**TWEED-NEW HAVEN REGIONAL AIRPORT**

**ADDENDUM NO. 2**

**REQUEST FOR PROPOSALS  
TERMINAL INFORMATION SYSTEMS FIDS/BIDS/GIDS & CMS  
TWEED-NEW HAVEN REGIONAL AIRPORT**

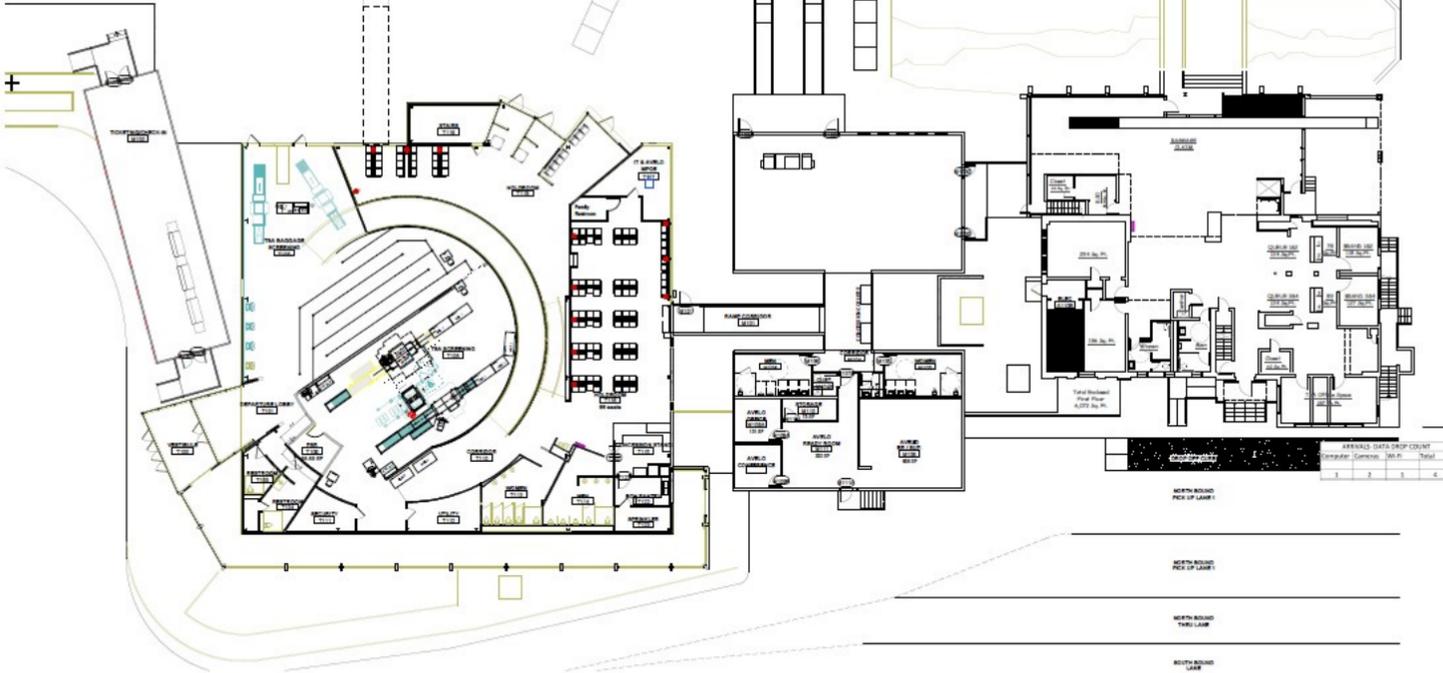
5. **Can you provide pictures?**

Yes. Pictures of the baggage belt will be provided in the addendum.

WEST TERMINAL 1ST. FLOOR PLAN

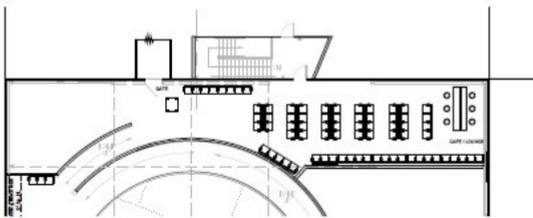
8. **XIII. C. Drawings are not included in the file HVN-Terminal-Information-Display-and-FIDS-RFP.pdf. Please provide drawings mentioned in this document.**

The floor plan is provided in the addendum.
